Access Compliance Report Public Rights-of-Way (Curb Ramps)

Main Street: N/A Cross Street: APRENDER_ST Location: N

ADA ID: RPRK211202135103 Ramp Type: Type 4 - Parallel Initial Pass/Fail: Fail Overall Compliance: No Severity Score: 32

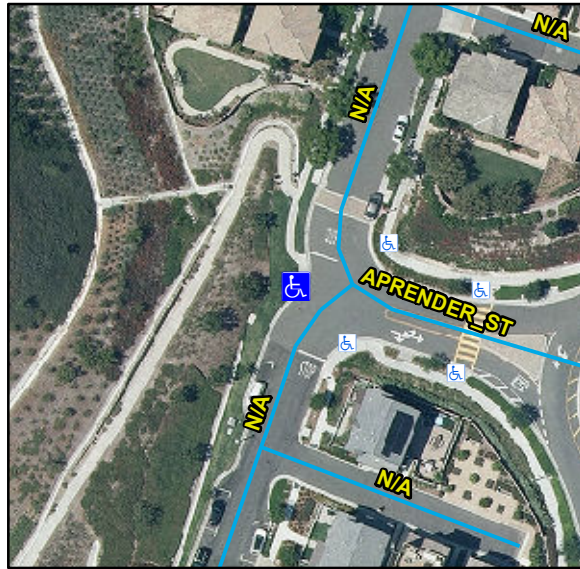
Compliance	Description	Data	Compliance	Description	Data
N/A	Ramp Length LT (in)	-9999	N/A	Ramp Length RT (in)	108
N/A	Ramp Width LT (in)	-9999	Yes	Ramp Width RT (in)	65
N/A	Ramp Run Slope LT (%)	-9999	No	Ramp Run Slope RT (%)	12.4
N/A	Ramp Cross Slope LT (%)	-9999	No	Ramp Cross Slope RT (%)	2.9
N/A	Landing Present	N/A	N/A	DWS Provided	N/A
N/A	Landing Length (in)	N/A	N/A	DWS Contrast	N/A
N/A	Landing Width (in)	N/A	N/A	DWS Length (in)	N/A
N/A	Landing Run Slope (%)	N/A	N/A	DWS Full Width	N/A
N/A	Landing Cross Slope (%)	N/A		DWS Offset Type	N/A
N/A	Landing Movement Obstructed?	N/A	N/A	DWS Offset Left (in)	N/A
	Landing Movement Type	N/A	N/A	DWS Offset Right (in)	N/A
N/A	Landing Shared	N/A			
N/A	Clear Space	N/A			
N/A	Clear Space To Crosswalk (in)	N/A			
N/A	Marked Crosswalk 1	No	N/A	Marked Crosswalk 2	N/A
	Crossing 1 Direction	E		Crossing 2 Direction	N/A
N/A	Marked Crosswalk 1 Width (in)	N/A		Marked Crosswalk 2 Width (in)	N/A

N/A	Ramp Inside Crosswalk 1	N/A	N/A	Ramp Inside Crosswalk 2	N/A
	Crossing 1 Slope (%)	0.5		Crossing 2 Slope (%)	N/A
	Crossing 1 Cross Slope (%)	3.9		Crossing 2 Cross Slope (%)	N/A
N/A	Gutter Ponding	N/A	N/A	Curb Slope	6.9
Yes	Gutter Lip Height (in)	0		Road Run Slope (%)	N/A
N/A	Gutter Run Slope (%)	N/A		Road Cross Slope (%)	N/A
N/A	Gutter Cross Slope (%)	N/A	Yes	Perpendicular Joint Present	Yes
Yes	Overall Surface Condition	Acceptable			
	Cross Gutter Present?	No		Spandrel Present?	No
	Replace Cross Gutter?	N/A		Replace Spandrel?	N/A

Remove & Replace Entire Ramp.

R304.3.2, R304.5.3, STD 1115
